Pump Supply Filter Kit for PPCH, P/N 3401429, includes (Pre-assembled):

Introduction

The PPCH Pump Supply Filter P/N 3068879 (103727) which is used on PPCH units built prior to December 2008 is being replaced with a more conductive filter. This kit facilitates the replacement of P/N 3068879 (103727) with P/N 3138000 (102808). It includes the replacement filter and a pre-attached extension tube to compensate for the difference in filter length.

Figure 1: Previous Pump Supply Filter P/N 3068879 (103727)

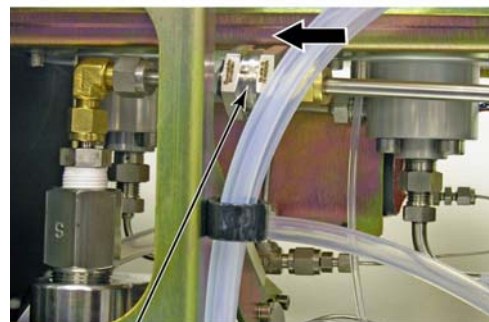
- ❺ Using 9/16 in. and 3/4 in. wrenches, loosen both sides of the existing pump filter 3068879 (103727) and short tube union that connects it to the pump inlet fitting. **Note direction of existing filter!** See **Figure 1**.
- ❻ Remove old filter 3068879 (103727) and tube union.
- ❼ Using 9/16 in. and 1 in. wrenches, install the new Filter Kit P/N 3401429. See **Figure 2**.
- ❽ Tighten fittings.
- ❾ If the PPCH has a Lo Q-RPT, set the system back to a normal position. Reconnect electrical power and drive air. Power up the PPCH.
- ❿ Perform pump prime procedure (see PPCH Operation and Maintenance Manual Section 5.10.1). Check filter connections for leaks.
- ⓫ Open reservoir **FILL/DRAIN** valve.
- ⓬ Close PPCH chassis (see PPCH Operation and Maintenance Manual Section 5.9).

Once this kit 3401429 has been installed any future pump supply filter replacements will require only the filter P/N 3138000 (102808).
